CITY OF ALBUQUERQUE

RE: **Lot 14 Block 7 Volcano Cliffs Unit 18 SAD 228
6515 Papagayo NW
Grading and Drainage Plan Revised for Pool
Engineers Stamp Date 12/23/2023 (D10D003L18)
Pad Certification Date 12/26/2023
Revised Building permit Date 4/18/2025**

ENGINEER'S SEAL	LOT 14 BLK 7 U 18 VC 6515 PAPAGAYO ROAD NW	DRAWN BY DEM
		DATE 10-20-23
	GRADING AND DRAINAGE PLAN	6515 Papagayo Rd. DWG
		SHEET # C1
DAVID SOULE P.E. #14522	P.O. BOX 53924 ALBUQUERQUE, NM 87199 (505) 321-8099	JOB #

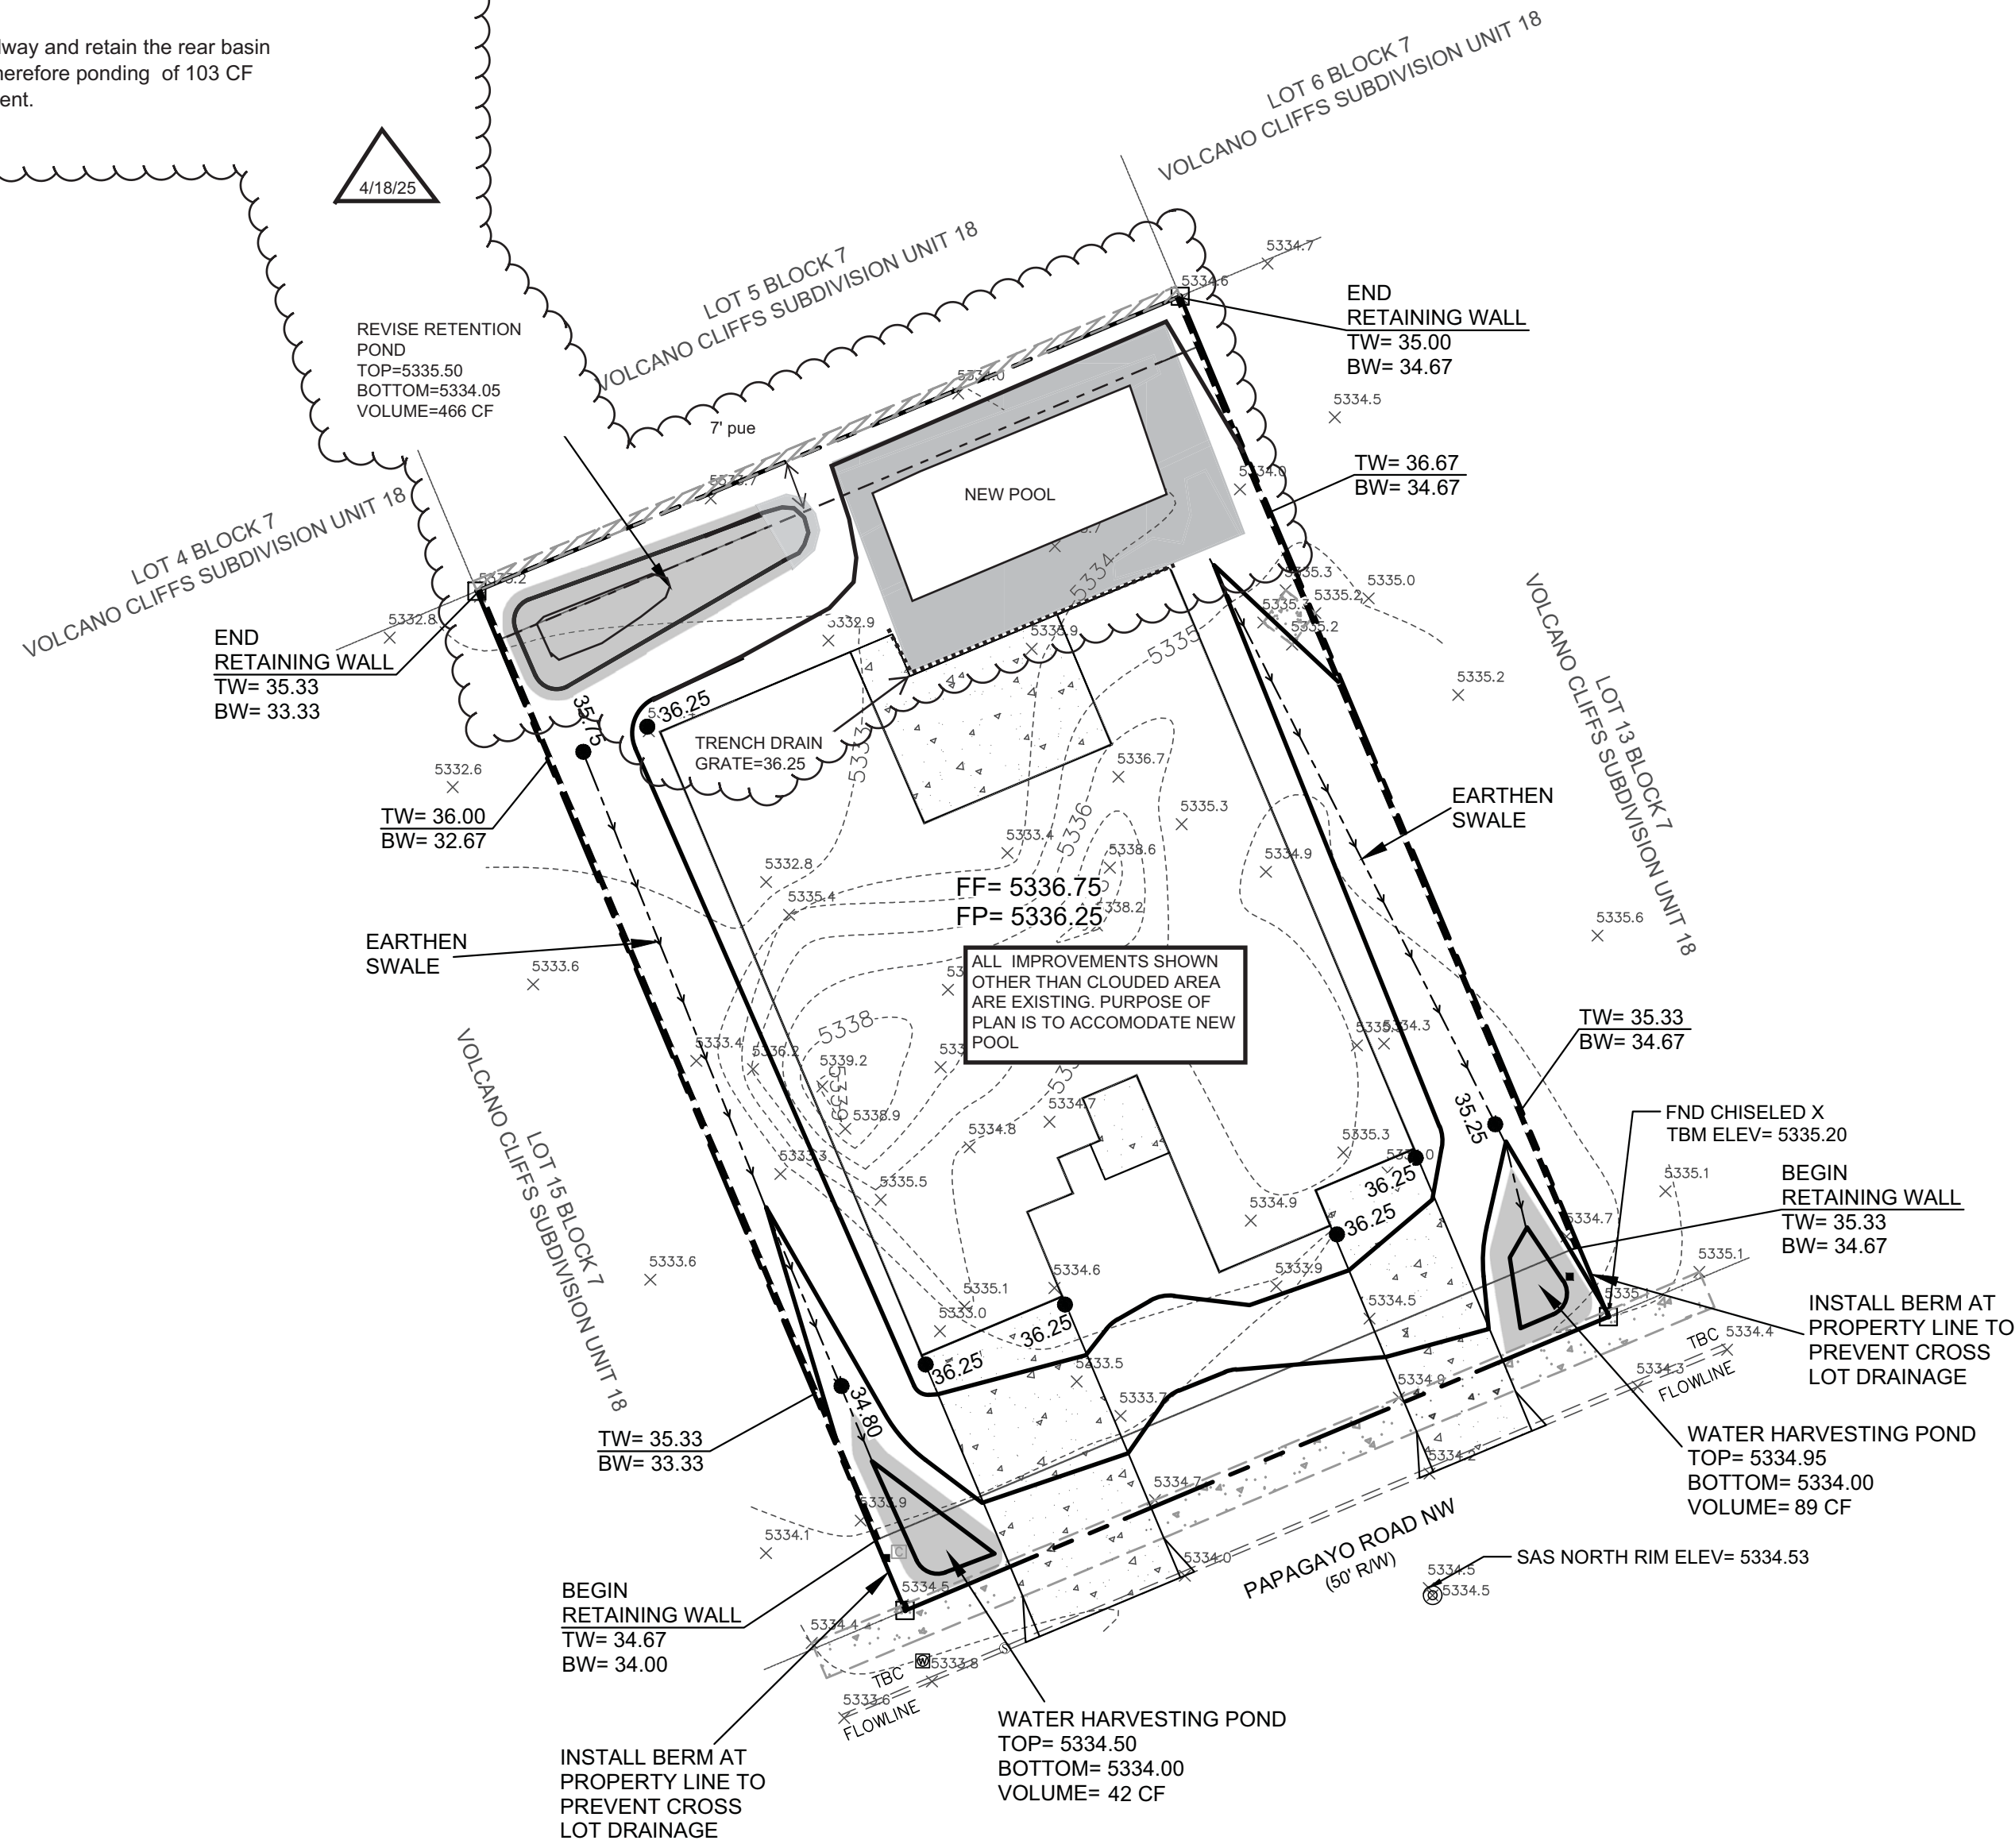
Based upon the information provided in your submittal received 4/21/2025, this revised plan to accept a swimming pool is approved for building permit.

Reiterate to the Owner/Contractor that a separate permit for a garden/retaining wall must be obtained, with the approved G&D plan and Pad Certification. Advise the owner & Contractor that dirt is not allowed in the public right of way to climb the curb. Crusher fines or lumber is allowed. If dirt is used this will delay going forward with the construction of the home.

Prior to Certificate of Occupancy release, Engineer Certification per the DPM checklist of this plan will be required.

4/18/25 CHANGES TO ORIGINAL GRADING PLAN ADDING POOL, UPDATING REQUIRED VOLUMES AND RESIZING POND TO ACCOMMODATE CHANGE, EXISTING PATTERNS AND CONCEPT TO CONFORM TO ORIGINAL PLAN AS SHOWN
